## ADDENDUM

Project Name: New Retaining Wall at: Lampe Hi-Rise (IL 16-4)

Addendum Number: 1

Issued: 01/13/2021

**SITE PLAN**  
SCALE: 1" = 30'-0"  
NORTH

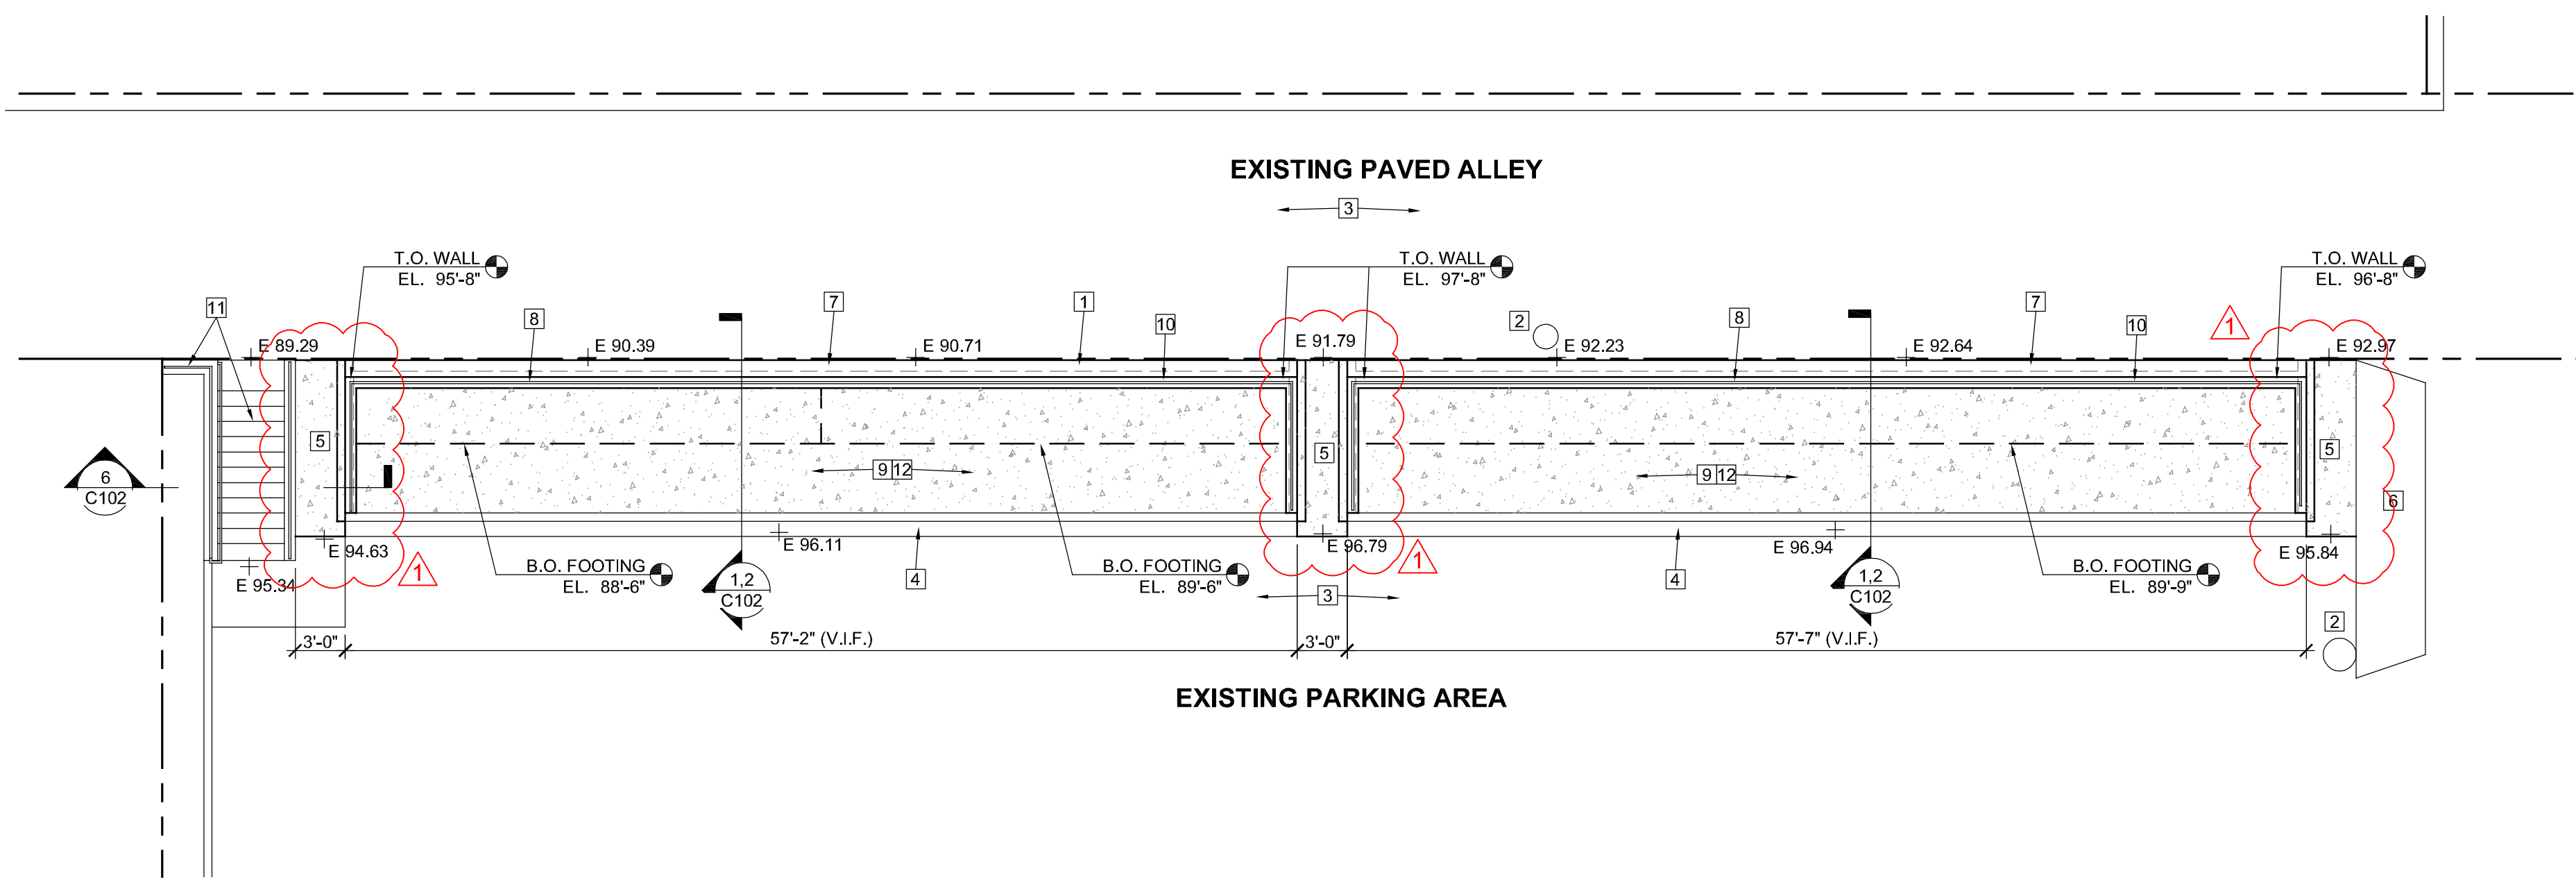
Drawings C101, C102	Revise	The existing concrete drainage ditches will be removed and replaced as part of this project. See attached revised drawings C101 and C102.
Detail 3/C102	Clarify	All guardrail steel shall be galvanized with paint finish, color as selected by Owner.
